ITEM FOR ENVIRONMENTAL BOARD AGENDA

**NAME & NUMBER
OF PROJECT:** EMBARCADERO
SP-06-0665D

MEMORANDUM

SUBJECT: Embarcadero (SP-06-0665D)
River Hills Road

CONSTRUCTION ON SLOPES
COMPARISON BETWEEN INITIAL AND
FINAL SITE PLAN LAYOUTS

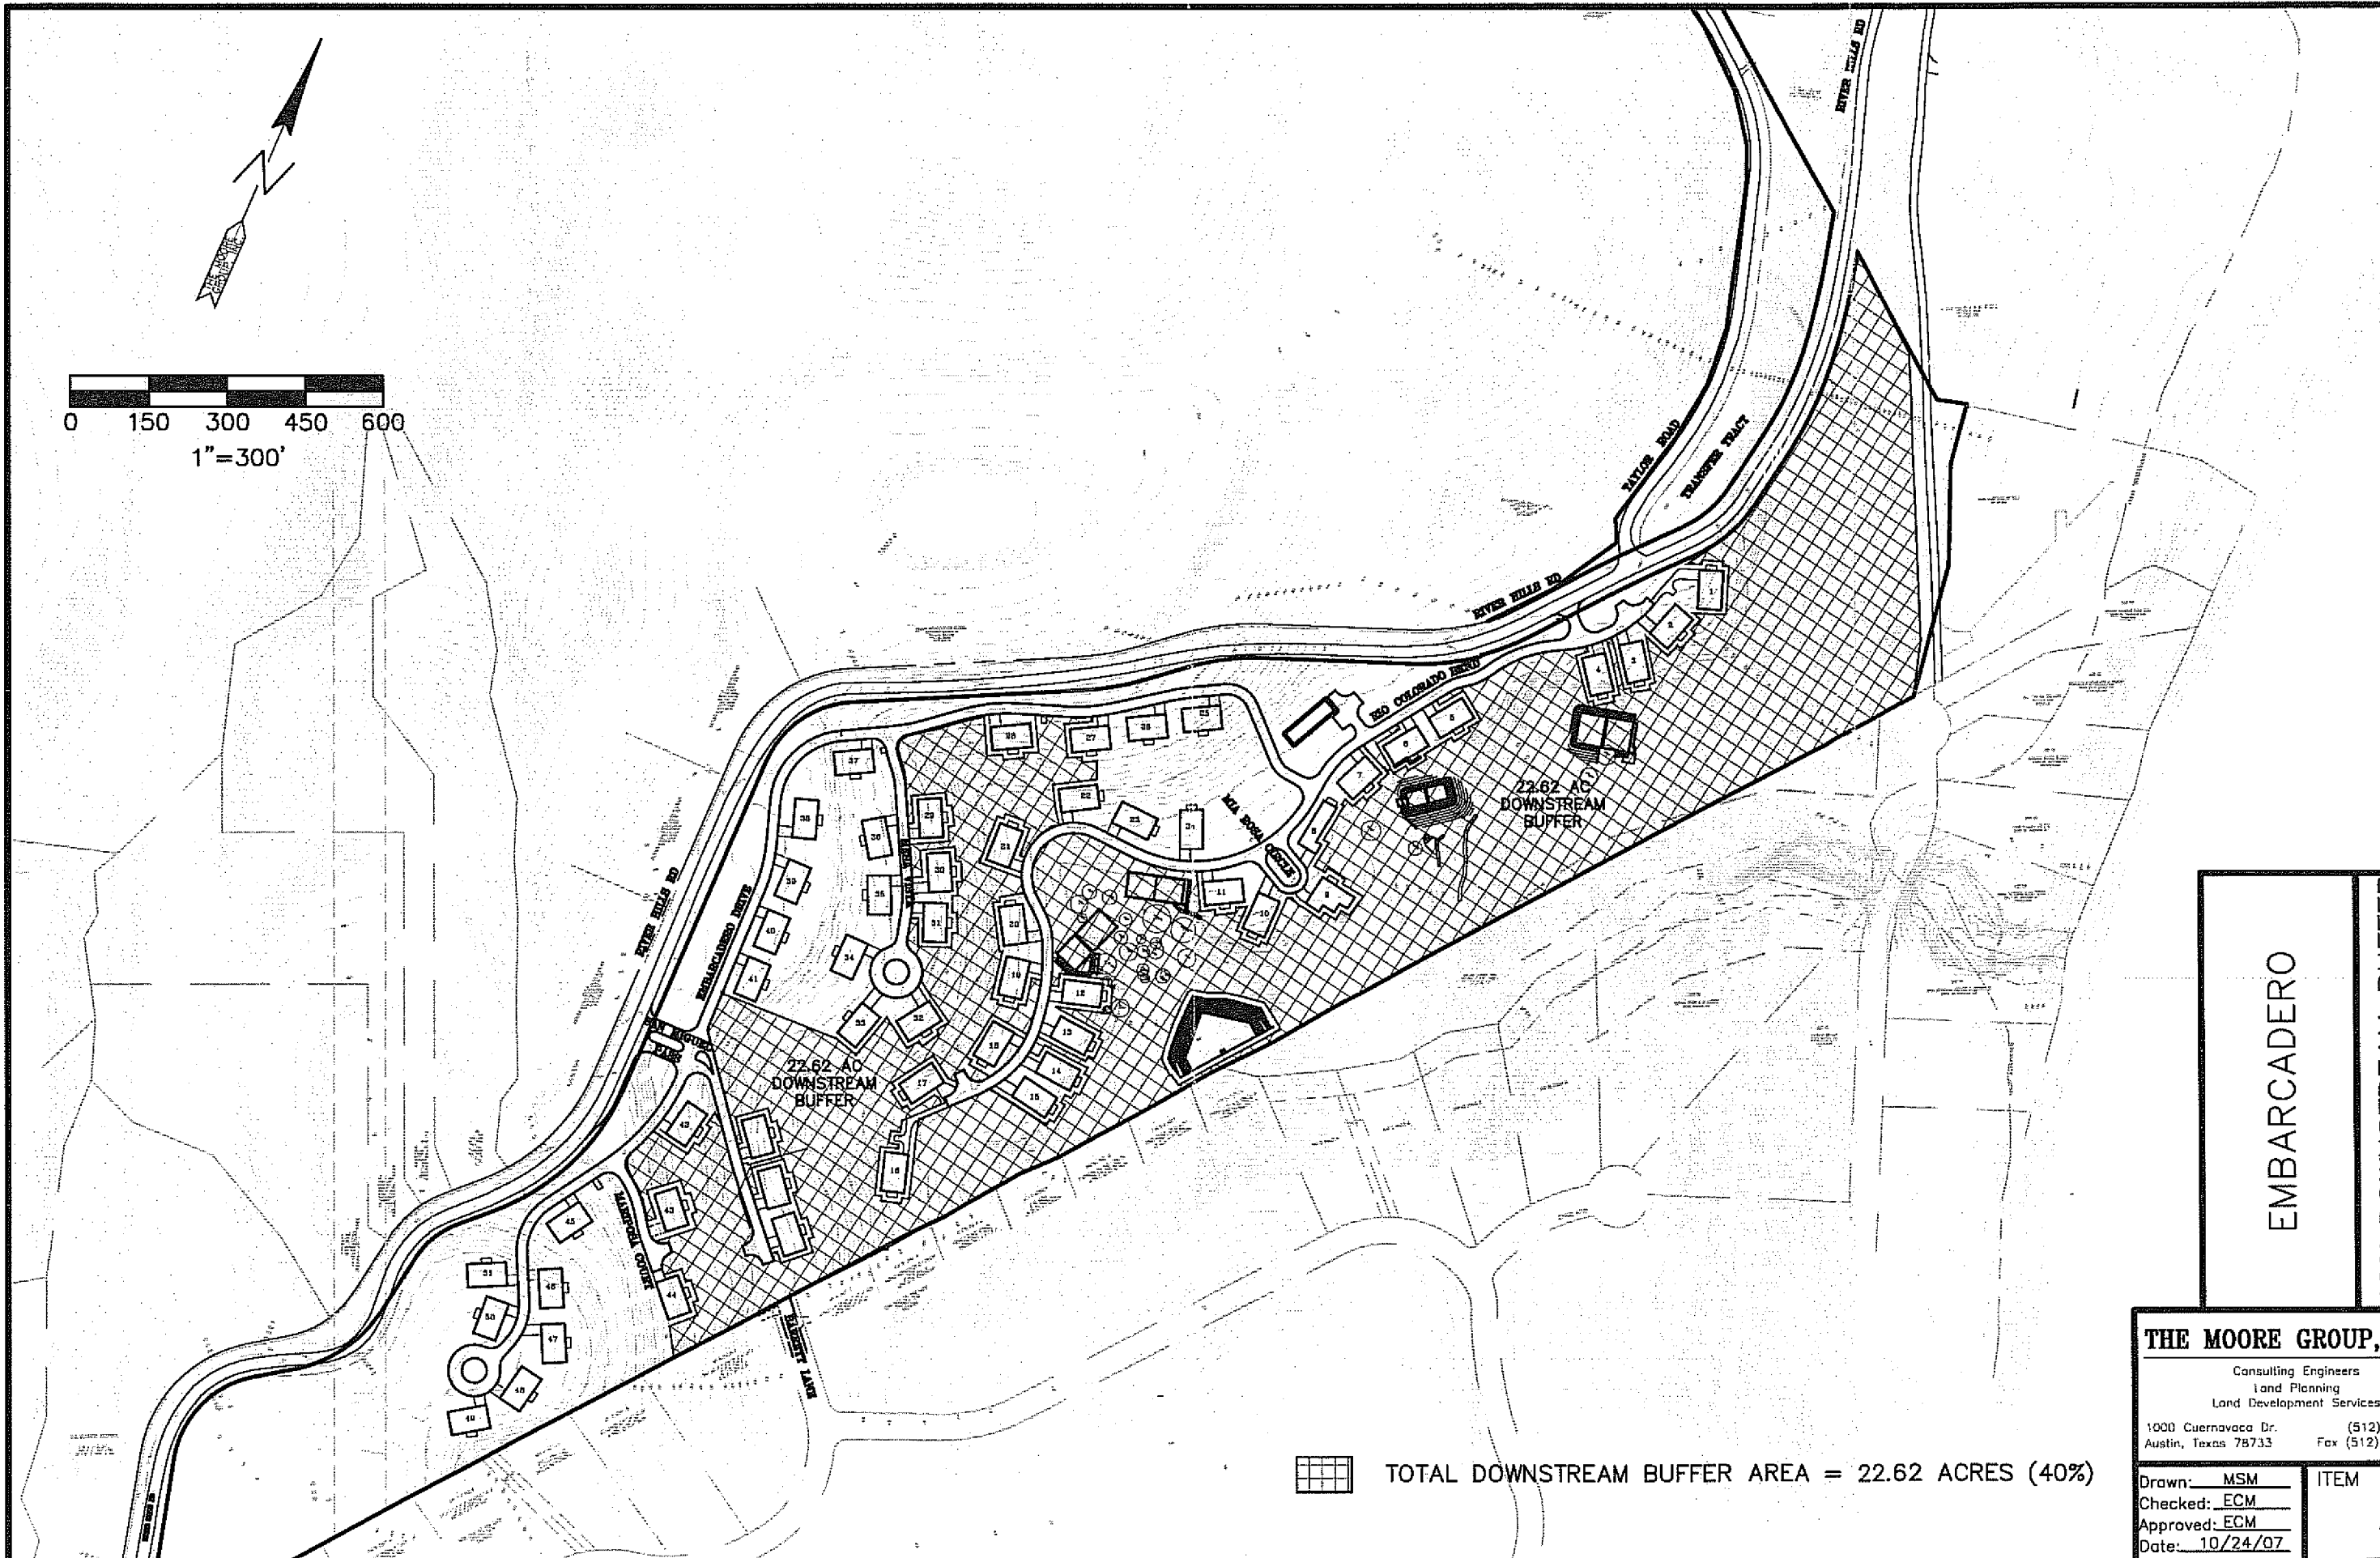
This variance is required to allow construction of portions of the condominium units on slopes greater than 25%. The applicant's design minimizes construction on slopes greater than 25%, while also ensuring adequate protection of the site's CEFs, and ensuring the wastewater irrigation fields are located on flatter areas which have deeper soil profiles for better effluent absorption. In working with City staff, the applicant reduced the construction on slopes greater than 25%, from 1.60 acres (or 69,696 square feet, or 3.09% gross site area/ 5.23% net site area) to 0.955 acres (or 41,560 square feet, or 1.84% gross site area/ 3.12% net site area). This is a reduction of 0.645 acres (or 28,096 square feet, 1.24% gross site area/ 2.11% net site area) on slopes greater than 25%.

Yes. Although the applicant is requesting a variance to construct on slopes greater than 25%, the majority of the buildings are constructed on slopes from 0 to 15%, but because of the site conditions listed above, portions of some of the units have been placed slopes greater than 25%. The applicant worked closely with City staff to ensure a minimum amount of construction takes place on slopes greater than 25%. In the initial plan submittal, the applicant was proposing 1.60 acres (or 69,696 square feet, or 3.09% gross site area/ 5.23% net site area) of development on slopes greater than 25%. After working with staff, the applicant reduced their need for construction on slopes greater than 25% to 0.955 acres (or 41,560 square feet, or 1.84% gross site area/ 3.12% net site area). This is a reduction of 0.645 acres (or 28,096 square feet, or 1.24% gross site area/ 2.11% net site area) on slopes greater than 25%.

EMBARCADERO WQ POND CUT-FILL EXHIBIT WATER QUALITY POND #1

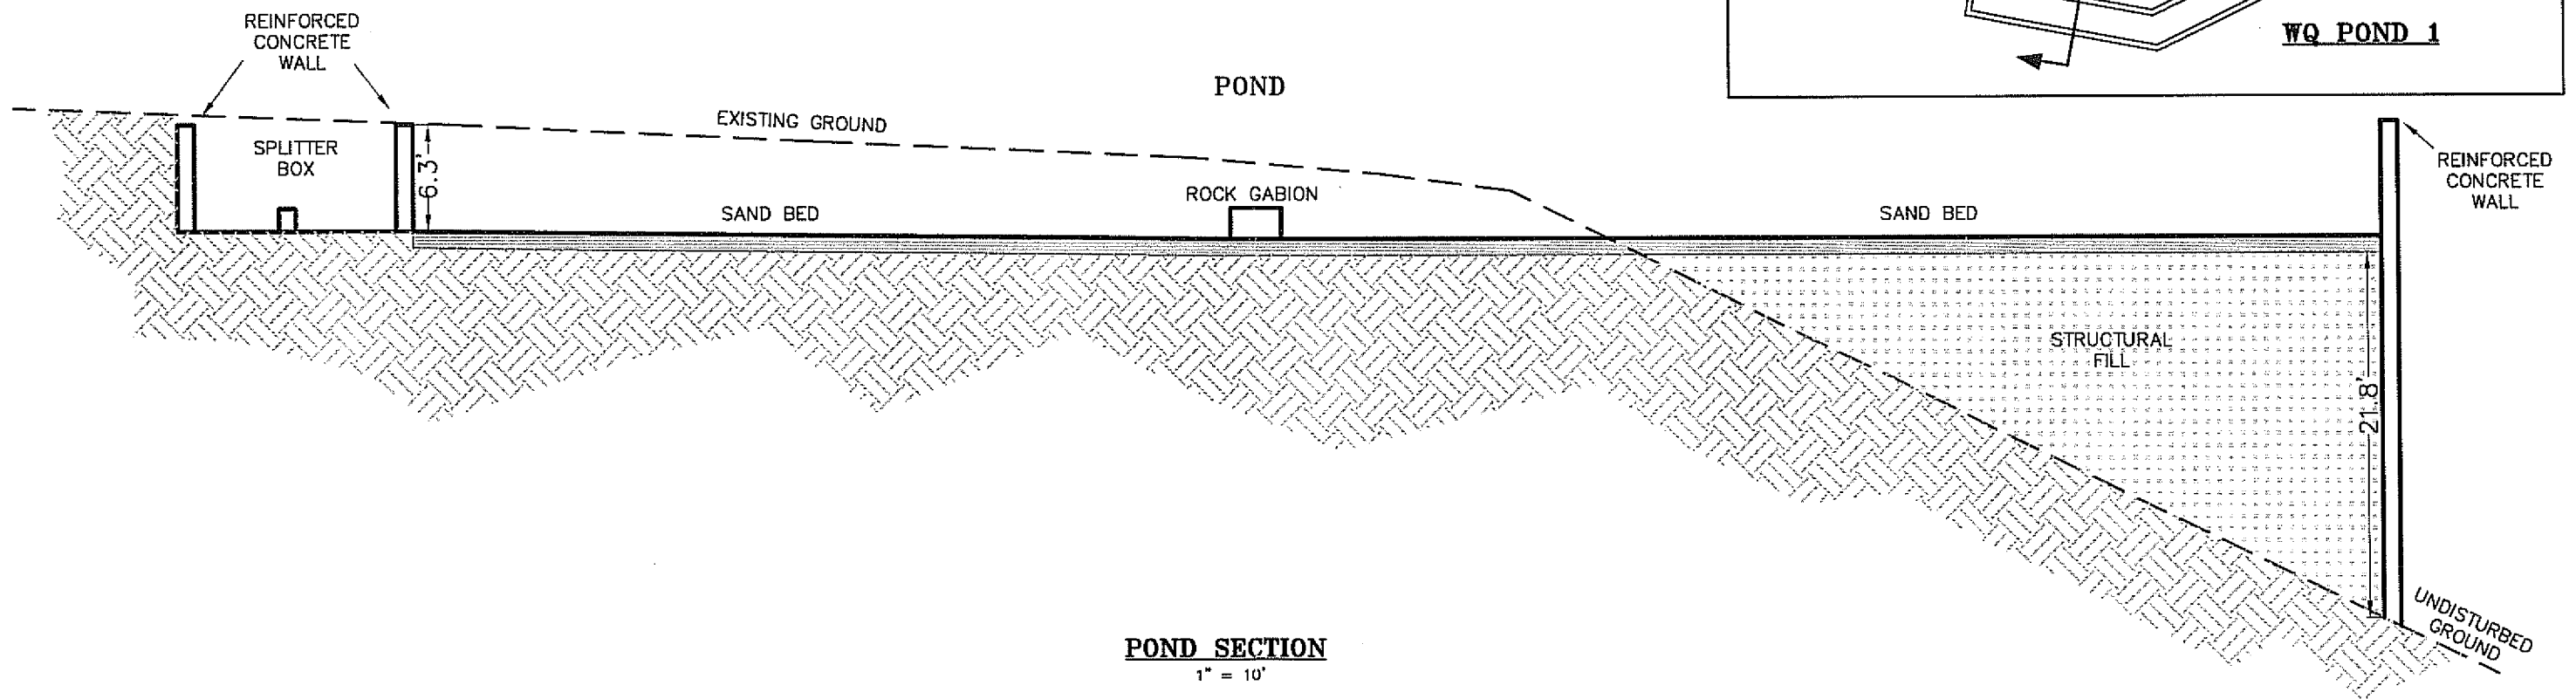
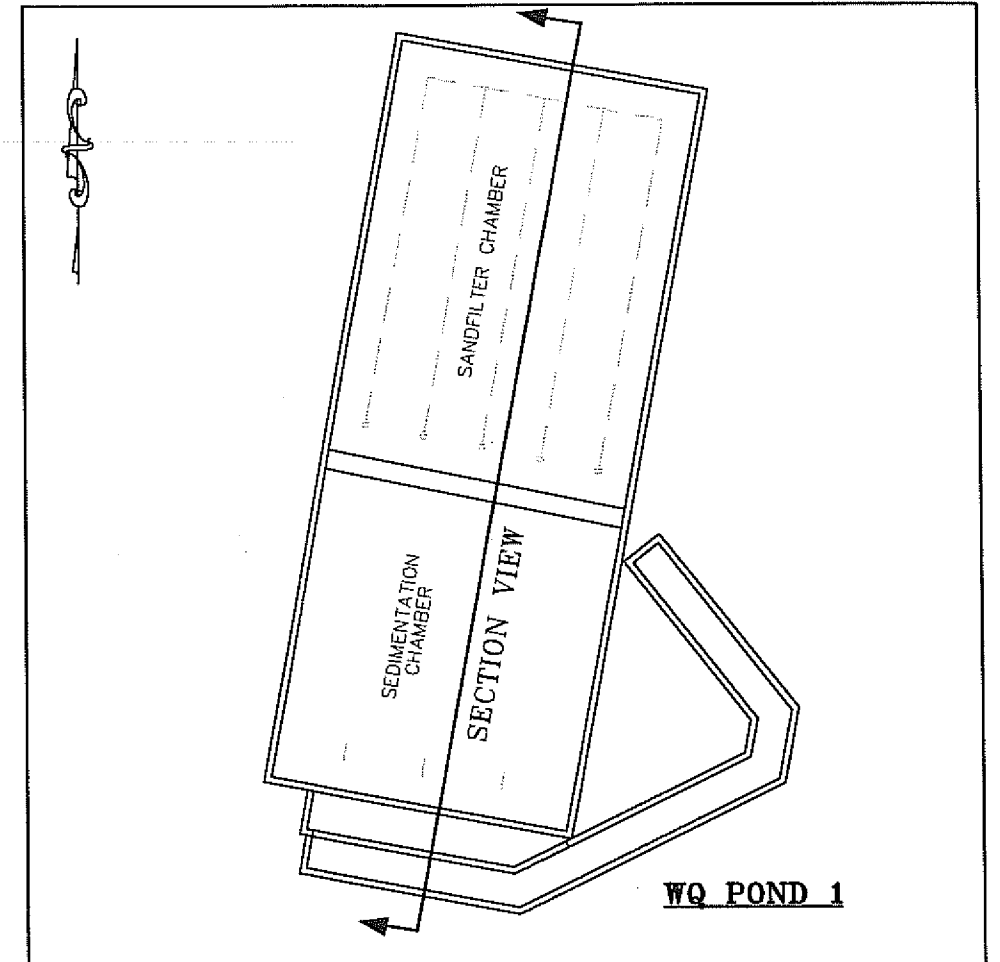
These variances were initially requested as an administrative variance (which is allowed by Code). However, due to the magnitude of the cut/fill staff felt it more appropriate to bring them to the EV Board with the other variances for their decision. Projects located in the Lake Austin Watershed do not require water quality controls if the impervious cover is less than 20%. On this project however, due to impervious cover transfers, the impervious cover will exceed 20% and therefore water quality requirements apply. There are 4 water quality ponds and 1 detention pond proposed for this project. Both the cut and fill variances are required to construct these ponds. Due to the topography of the property, all of these ponds will all be located on slopes, which is allowed by the City Code. The location of these ponds on slopes increases the magnitude of cut/fill required. However, these deeper ponds will minimize the footprint of the ponds. If the ponds were designed shallow, their size would be much larger than the ponds currently designed. Below is a table that outlines the maximum cut/fill for each pond:

Pond	Maximum Cut	Maximum Fill
Water Quality Pond 1	7.2 feet	24.15 feet
Water Quality Pond 2	7.0 feet	16.0 feet
Water Quality Pond 3	12.24 feet	24.0 feet
Water Quality Pond 4	32.2 feet	15.0 feet
Detention Pond	25.1 feet	No fill

Water Quality ponds 1 thru 3 will all have fill that is structurally compacted and will be retained by a vertical reinforced concrete retaining wall and water quality pond 4 will be constructed of structural compacted fill stabilized and armored by mortared stacked rock placed at a slope of 1 to 1. The detention pond will be cut out of the slope and will have a vertical reinforced concrete retaining wall. Once these ponds are constructed, stabilized, and used, the overall water quality from site run-off will be improved.
